Access Compliance Report

Public Rights-of-Way

(Curb Ramps)

Intersection ID: 14655	Main Street: CAMERON_AV	Cross Street: E_5TH_ST	Location: NW
ADA ID: E06ED85FD774	Ramp Type: BlendTrans2	Initial Pass/Fail: Fail	Overall Compliance: No
		Severity Score: 1.25

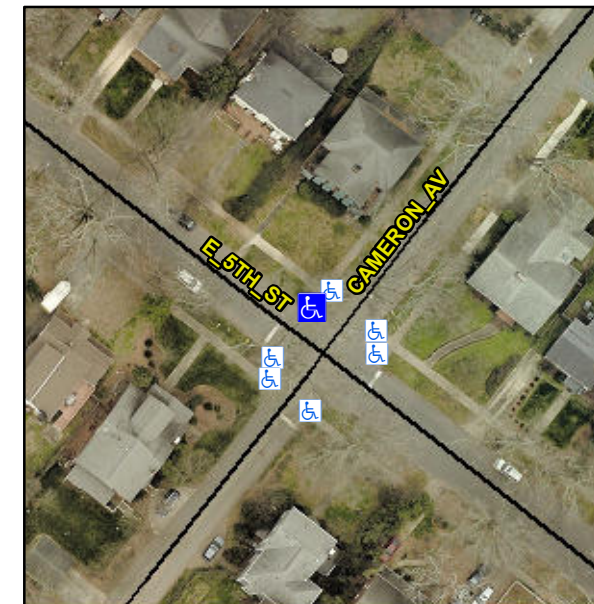
R304.5.3

Compliance	Description	Data	Compliance	Description	Data
N/A	Ramp Length (in)	32.0	Yes	BlendTrans Slope (%)	3.0
Yes	Ramp Width (in)	48.0	No	BlendTrans XSlope (%)	2.3
N/A	Flare Type LT	N/A	N/A	Flare Type RT	N/A
N/A	Flare Slope LT (%)	N/A	N/A	Flare Slope RT (%)	N/A
N/A	Flare Traversable LT?	N/A	N/A	Flare Traversable RT?	N/A
N/A	Landing Length (in)	N/A	N/A	DWS Provided?	N/A
N/A	Landing Width (in)	N/A	N/A	DWS Contrast?	N/A
N/A	Landing Slope (%)	N/A	N/A	DWS Length (in)	N/A
N/A	Landing X Slope (%)	N/A	N/A	DWS Full Width?	N/A
N/A	Landing Curb? (Y/N)	N/A	N/A	DWS Offset (in)	N/A
N/A	Shared Landing?	N/A			
N/A	Gutter Ponding?	Yes	N/A	Gutter Slope (%)	N/A
N/A	Gutter Lip Ht (in)	N/A	N/A	Gutter X Slope (%)	N/A
N/A	Painted X Walk1?	No	N/A	Painted X Walk2?	N/A
	X Walk 1 Direction	To SW		X Walk 2 Direction	N/A
	X Walk 1 Width (in)	N/A		X Walk 2 Width (in)	N/A
	X Walk 1 Slope (%)	5.4		X Walk 2 Slope (%)	N/A
	X Walk 1 X Slope (%)	1.1		X Walk 2 X Slope (%)	N/A

Remove & Replace Curb Ramp With Two New Directional Ramps or Equivalent.
